SUBJECT: ISSUANCE OF AMENDMENTS - JOSEPH M. FARLEY NUCLEAR PLANT,
 UNITS 1 AND 2 (TAC NOS. M99136 AND M99137)

The Nuclear Regulatory Commission has issued the enclosed Amendment No. 133 to Facility Operating License No. NPF-2 and Amendment No. 125 to Facility Operating License No. NPF-8 for the Joseph M. Farley Nuclear Plant, Units 1 and 2. The amendments change the Technical Specifications (TS) in response to your submittal dated June 30, 1997, as supplemented September 25, 1997. The revision supplemented the TS Bases to discuss credit for boraflex panels in the revised criticality analysis. The staff found that the supplement did not change the conclusions of the proposed no significant hazards consideration; therefore, renotification of the Commission's proposed determination of no significant hazards consideration was not necessary.

The amendments change the Farley TS to incorporate requirements necessary to change the basis for prevention of criticality in the fuel storage pool. The change eliminates the credit for Boraflex as a neutron absorbing material in the fuel storage pool criticality analysis. The change also establishes an alternate method for maintaining the recomm

Figure 5.6-2 Spent Fuel Storage Configurations

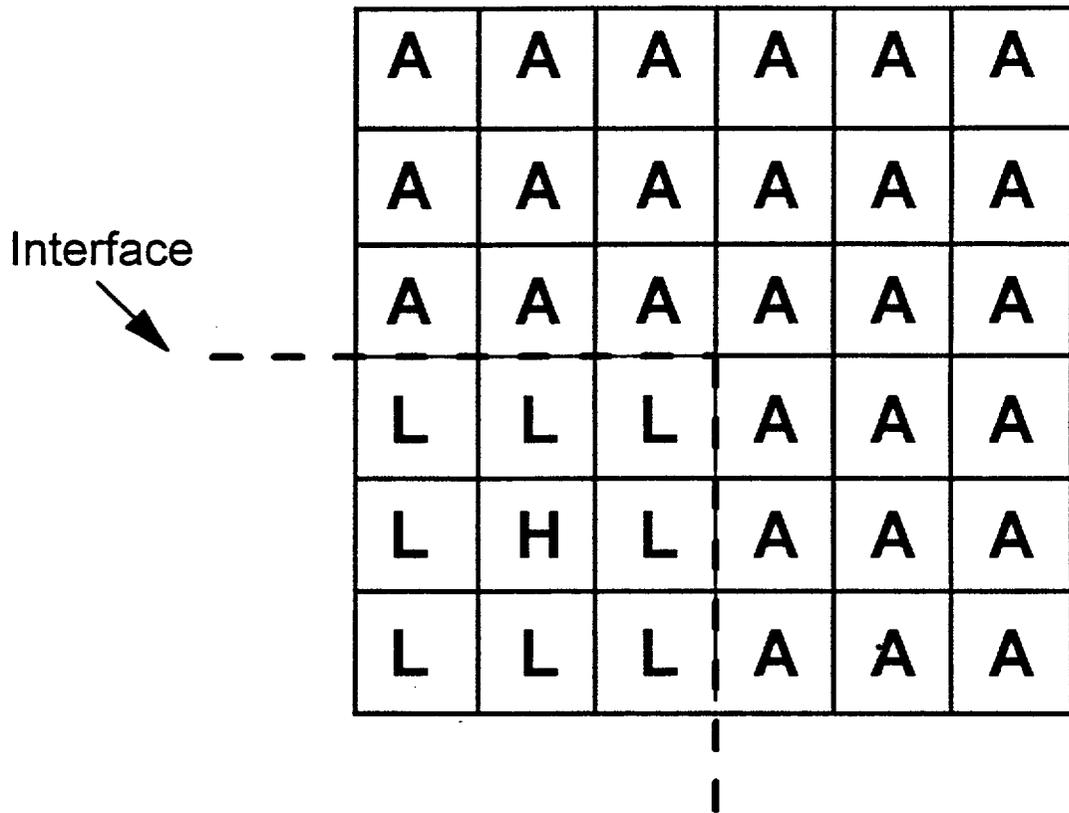
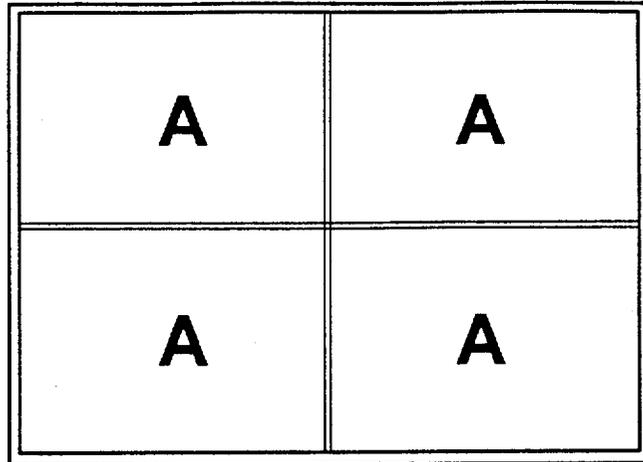
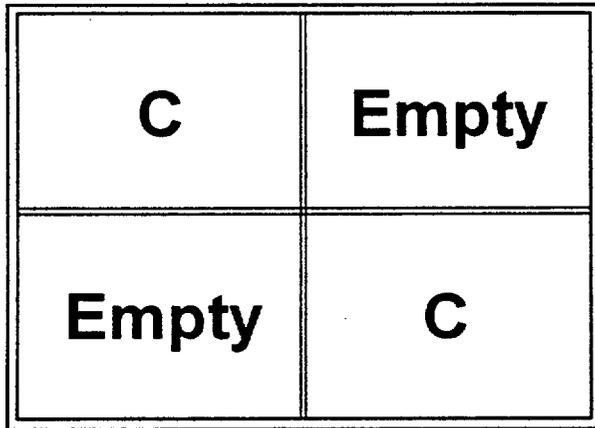
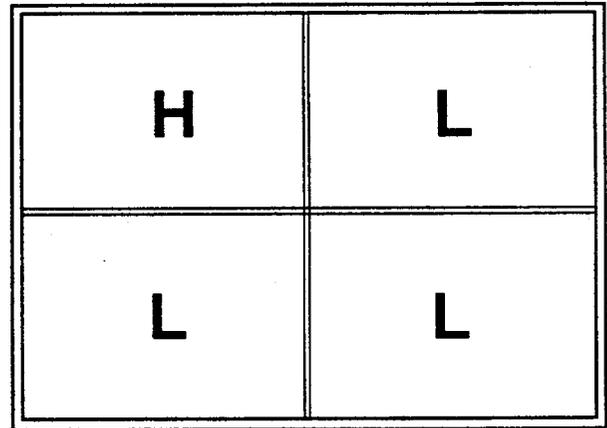
Westinghouse 17X17 fuel assemblies with nominal enrichments less than or equal to 5.0 w/o U-235 can be stored in a 2 out of 4 checkerboard arrangement as shown in Figure 5.6-2. In the 2 out of 4 checkerboard storage arrangement, 2 fuel assemblies can be stored corner adjacent with 2 empty storage cells.

Westinghouse 17X17 fuel assemblies can be stored in a burned/fresh checkerboard arrangement of a 2X2 matrix of storage cells as shown in Figure 5.6-2. In the burned/fresh 2X2 checkerboard arrangement, three of the fuel assemblies must have an initial nominal enrichment less than or equal to 1.6 w/o U-235, or satisfy a
